Revision History

Revision 1 - March 2, 2007. Updated based on new SNW-3 speed negotiation window, and multiplexxing.

Revision 2 - March 21, 2007. Updated based on comments from March working group meeting.

Proposed Changes**6.8.1 SP state machine overview**

Figure 117 — SP (phy layer) state machine - OOB sequence states

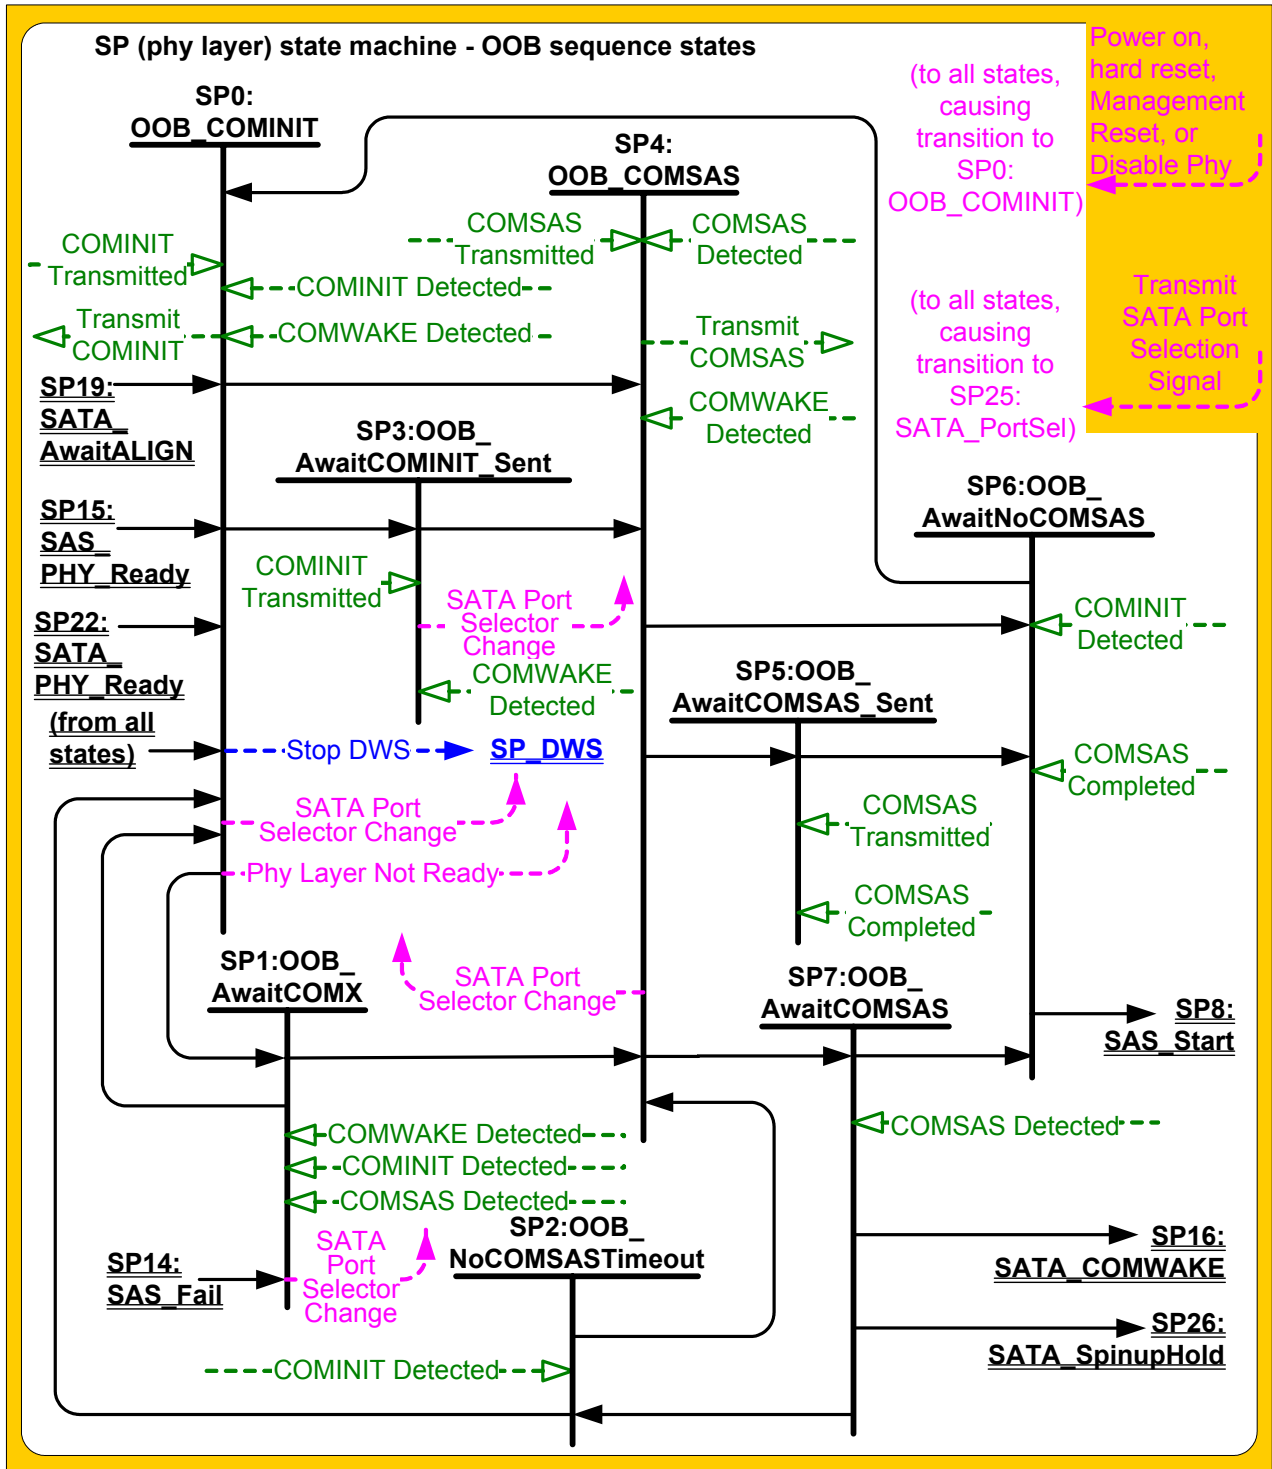
[Before the transition, if this state was entered from SP0:OOB_COMINIT, this state shall set the ResetStatus state machine variable to UNKNOWN.](#)

[Editor's Note 2: This is to get the variable cleared when there isn't a device responding to anything anymore, and not have lingering RESET_IN_PROGRESS, PHY_RESET_PROBLEM, etc.](#)

[Before the transition, this state shall set the ResetStatus state machine variable to UNKNOWN.](#)

Figure 118 — SP (phy layer) state machine - SAS speed negotiation states

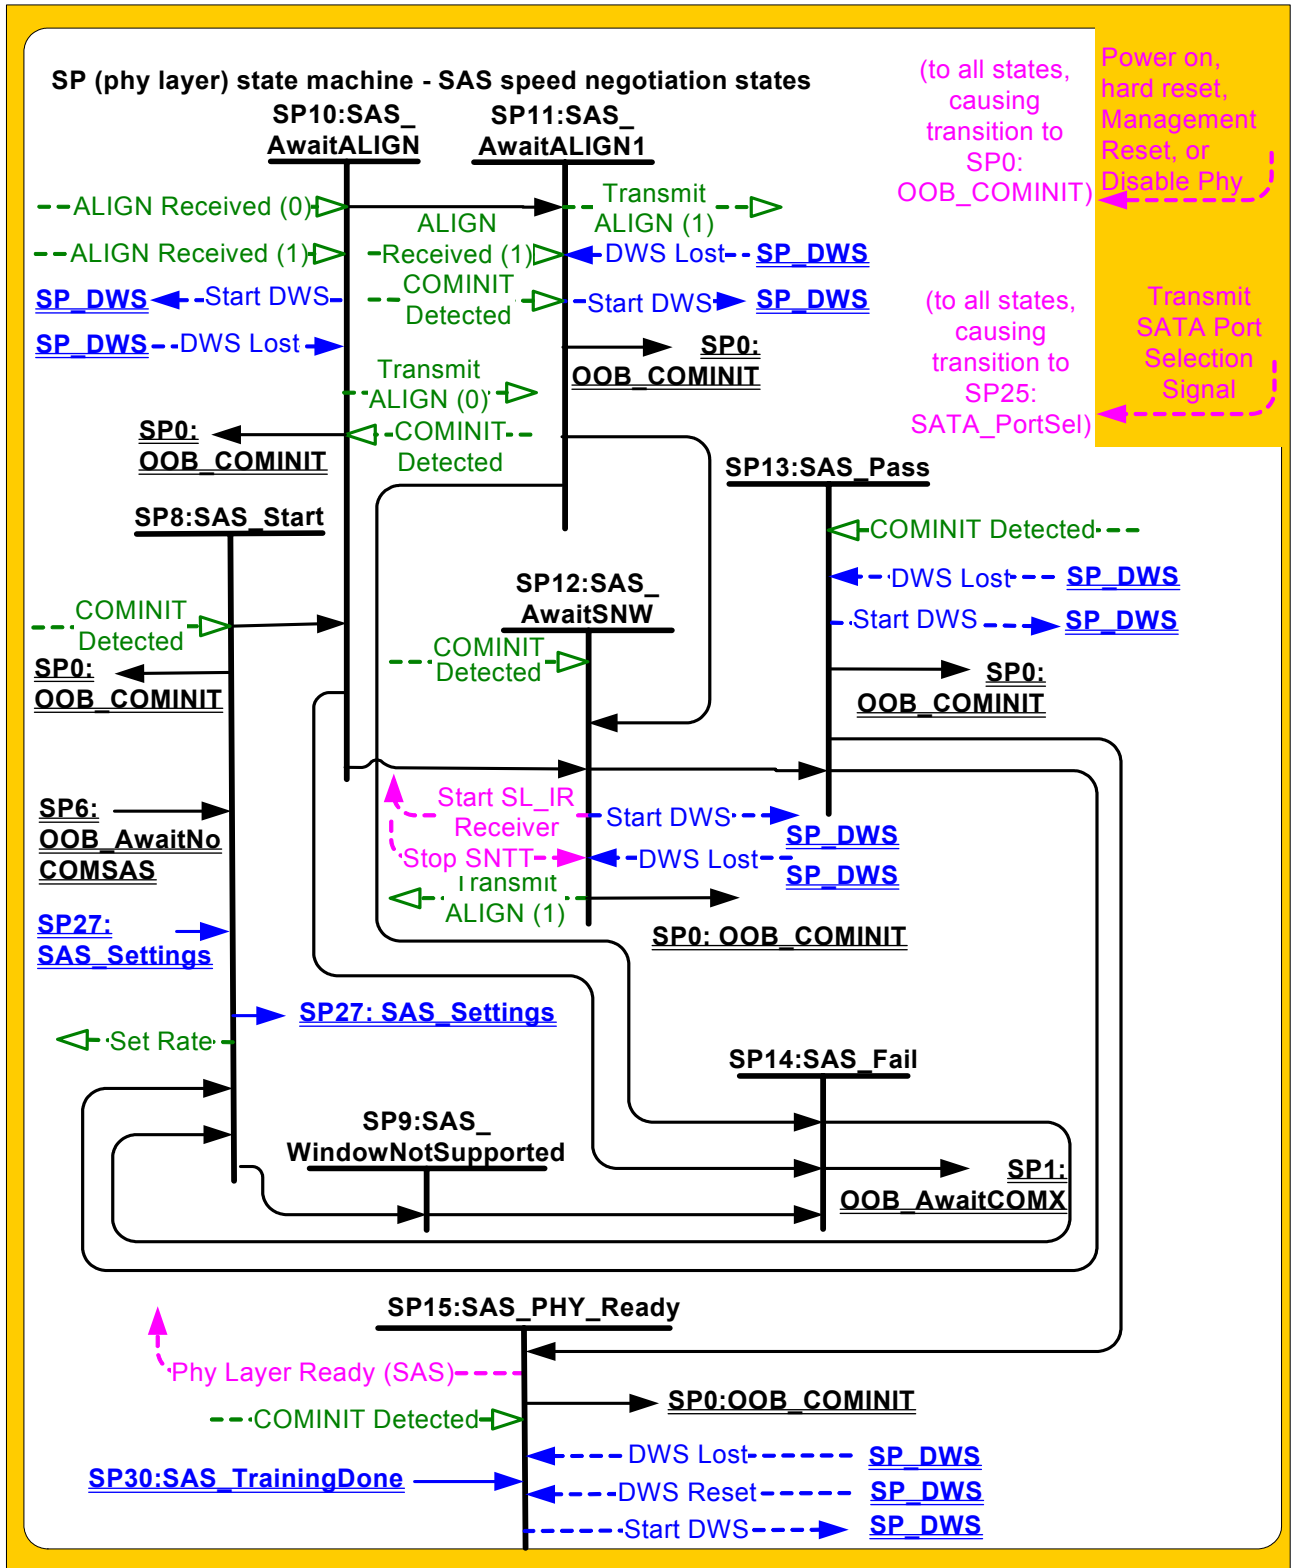
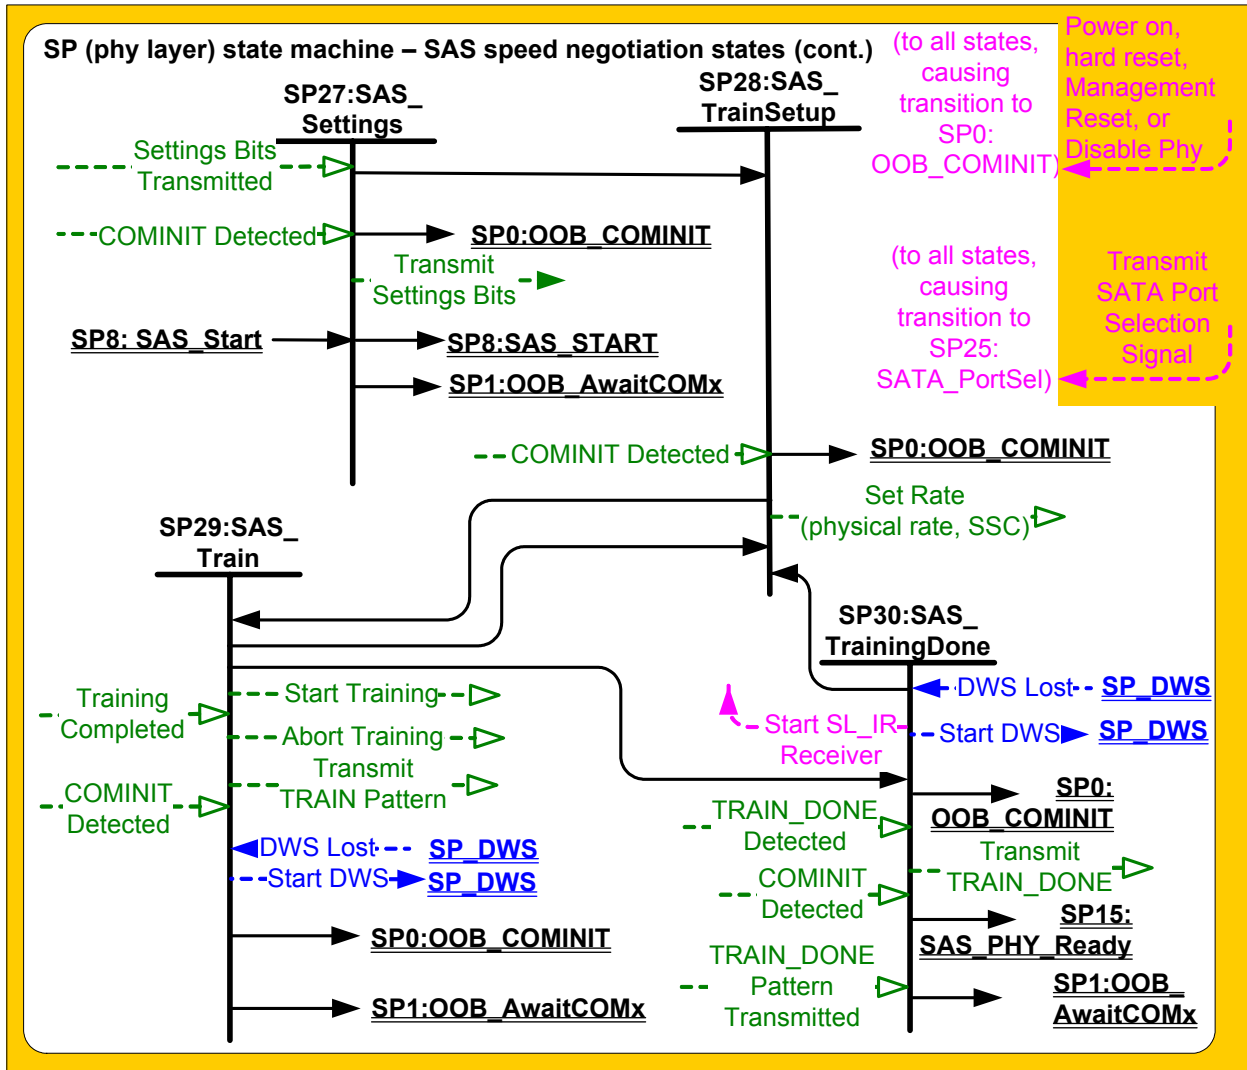
[Before the transition, this state shall set the ResetStatus state machine variable to UNKNOWN.](#)

This transition shall occur if the Current SNW state machine variable is set to [Phy-Reset-Problem Unsupported Phy Attached](#).

[Before the transition, this state shall set the ResetStatus state machine variable to UNSUPPORTED_PHY_ATTACHED.](#)

[Before the transition, this state shall set the ResetStatus state machine variable to PHY_RESET_PROBLEM.](#)

- a) [if the SP transmitter is transmitting at 1.5Gbps, set the ResetStatus state machine variable to G1;](#)
- b) [if the SP transmitter is transmitting at 3.0Gbps, set the ResetStatus state machine variable to G2; or](#)
- c) [if the SP transmitter is transmitting at 6.0Gbps, set the ResetStatus state machine variable to G3.](#)

Figure 121 — SP (phy layer) state machine – SATA port selector state

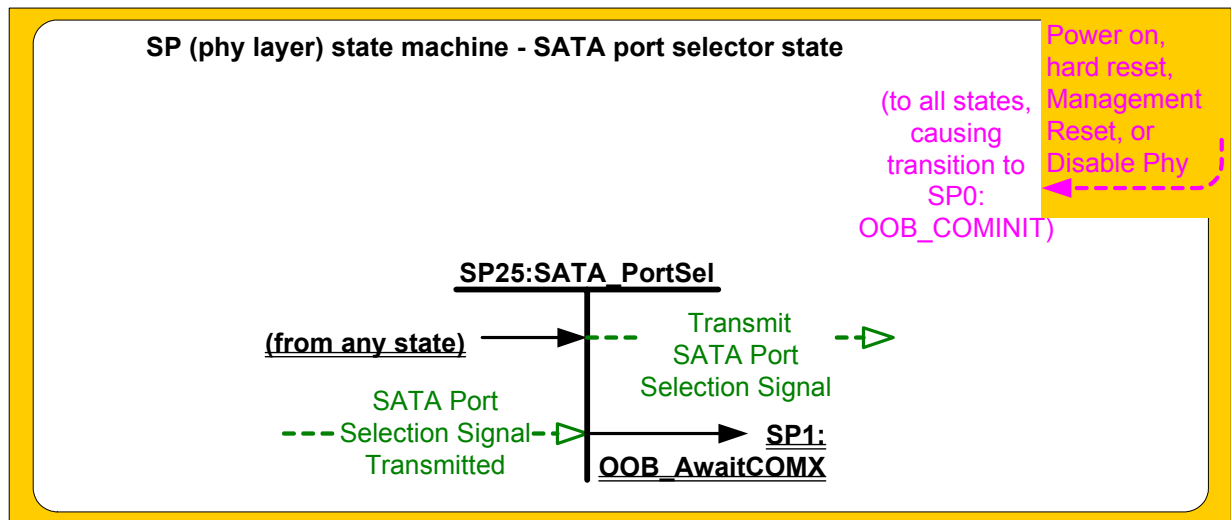
- [set the ResetStatus state machine variable to UNKNOWN;](#)
- send a Transmit SATA Port Selection Signal message to the SP transmitter;
- set the ATTACHED SATA PORT SELECTOR bit to zero in the SMP DISCOVER response (see 10.4.3.7) and the SMP DISCOVER LIST response (see 10.4.3.13.3); and
- set the ATTACHED SATA DEVICE bit to zero in the SMP DISCOVER response and the SMP DISCOVER LIST response.

Figure 122 — SP (phy layer) state machine - SATA spinup hold state

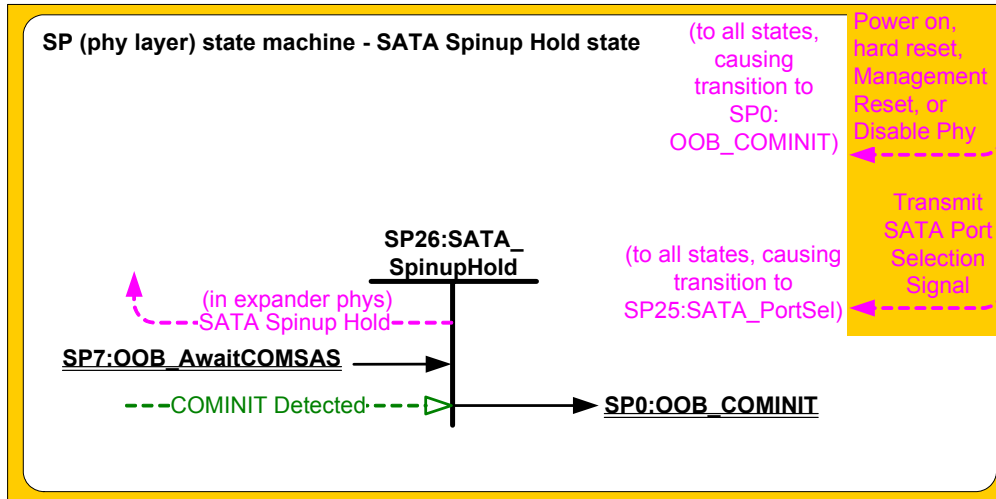
[Upon entry into this state, this state shall set the ResetStatus state machine variable to SPINUP_HOLD.](#)
